Technical Support Bulletin
IDX 4000 Seagate Barracuda
ES.2 Speed Jumper Setting

037-0017-01

TSB Description		TSB Number
IDX 4000 Seagate Disk Drive Jumper Settings		
Product	Module	Model
Seagate Barracuda ES.2	N/A	ST31000340NS
Operating Systems	BIOS	Driver
N/A	N/A	N/A
Symptoms		
IDX4000 IGC systems may encounter a Degraded RAID 1 logical drive or Delayed Writes during large data transfers.		
Fixes	Scheduled Date Available	
Any IDX4000 IGC with above symptoms.	N/A	
Work-A-Rounds		
Use the instructions contained herein to update your IDX4000 IGC RAID 1 system drives.

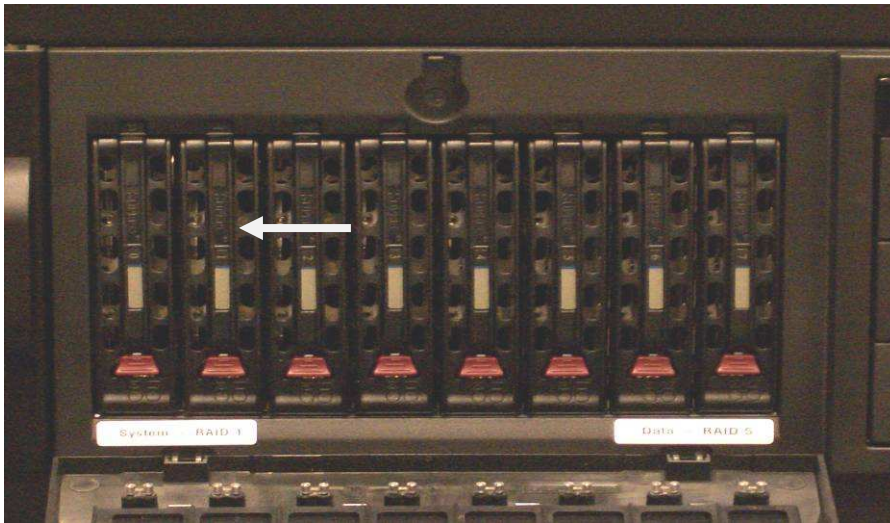
4. Install a 2mm jumper onto the disk drive to reduce the speed from 3.0 Gbits per second to 1.5 Gbits per second. Refer to the next picture for jumper placement. The drive has a label affixed that also shows how to set the jumper.
